**Amended Response to Request for Additional Information
No.107-1293 Revision 0**

**US-APWR Design Certification
Mitsubishi Heavy Industries
Docket No. 52-021**

RAI NO.: NO. 107-1293 REVISION 0
SRP SECTION: 03.09.04 – CONTROL ROD DRIVE SYSTEMS
APPLICATION SECTION: 3.9.4
DATE OF RAI ISSUE: 11/24/08

QUESTION NO. : RAI 1293-01

Figure 1 Applied Area of the Chrome Carbide Coating

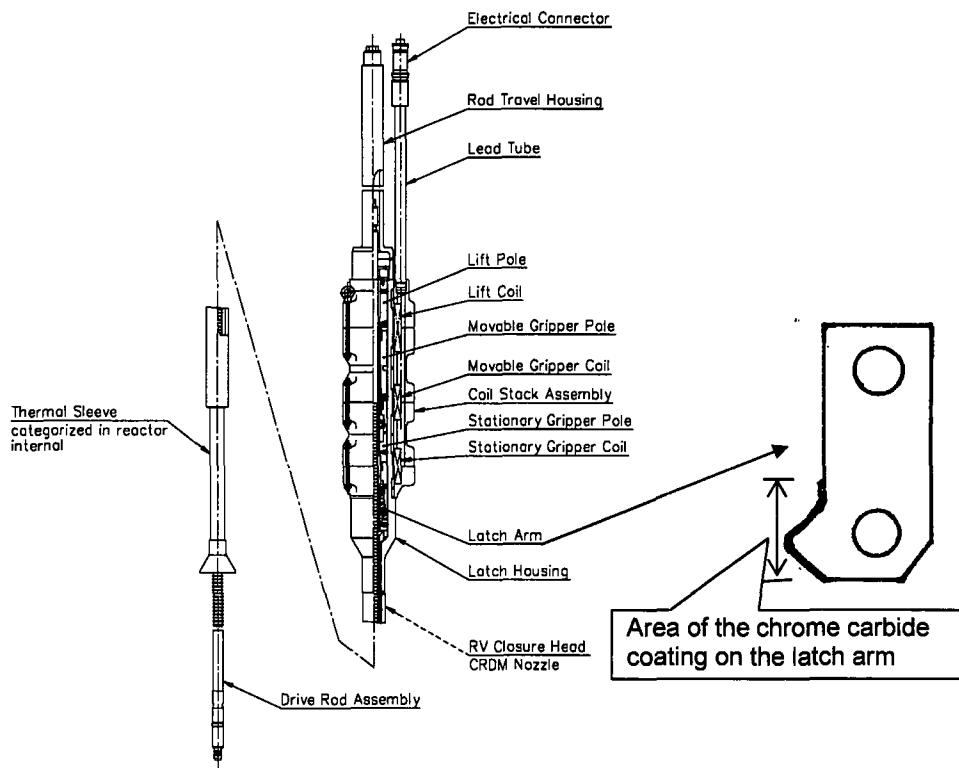
- a. Describe differences between the US-APWR and the previous design, such as the L-106A CRDM and discuss their effects on the applicability of the previous operability tests to the US-APWR CRDM. US-APWR DCD Tier 2, Section 3.9.4.1.1 (page 3.9-56) states that the US-APWR CRDM design is improved by (1) butt welding the CRDM latch housing to the CRDM nozzle on the reactor vessel closure head and (2) applying a chrome carbide coating to the latch arms.

The design of the US-APWR CRDM latch assembly is the same as the previous L-106A type CRDM, except the chrome carbide coating on the latch arms to improve wear resistance. The latch assembly is shown in Figure 1. This design change does not affect operability, since the thickness of the chrome carbide coating is thin enough compared with the clearance between the latch tip and the groove of the drive rod.

Thickness of the chrome carbide coating on the latch arm is [] mils, which is thin enough compared with the approximately [] in clearance between the latch tip and groove of the drive rod. Therefore, chrome carbide coating does not affect operability.
